Product/Process Change Notice (PCN)

PCN #: ConCRD_20170301

Product Affected: 693010020611

PCN Date: March 14th, 2017Effective Date: June 14th, 2017

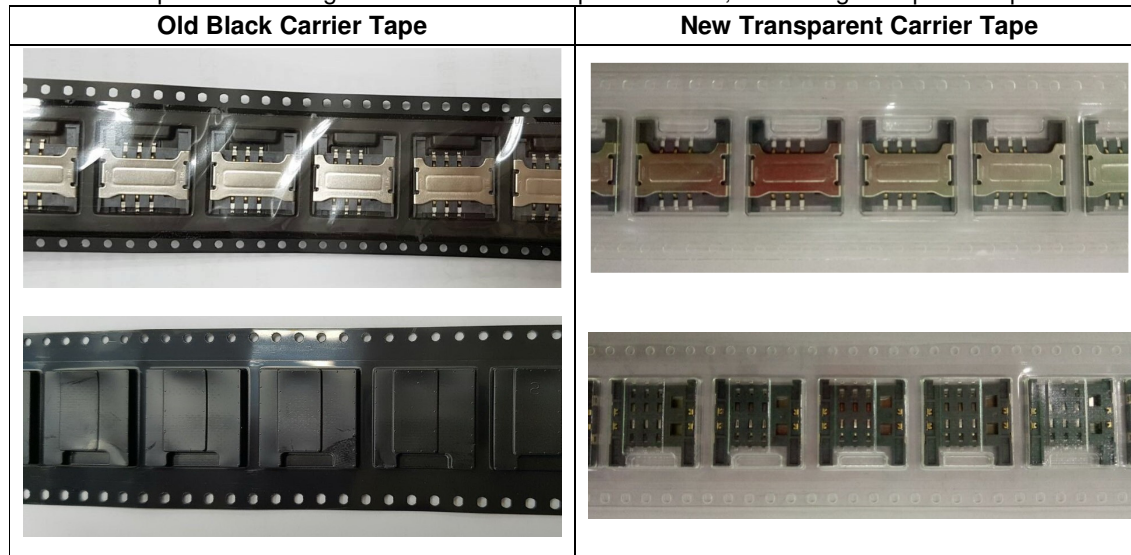
For process improvement purposes, Würth Elektronik will change the colour of the carrier tape. After product change with effective date of 14th June 2017, the new packaging will be available with Date Code 2017-03-15 / First lot number: 225010011707000.

The carrier tape will be changed from black to transparent colour, facilitating the optical inspection.
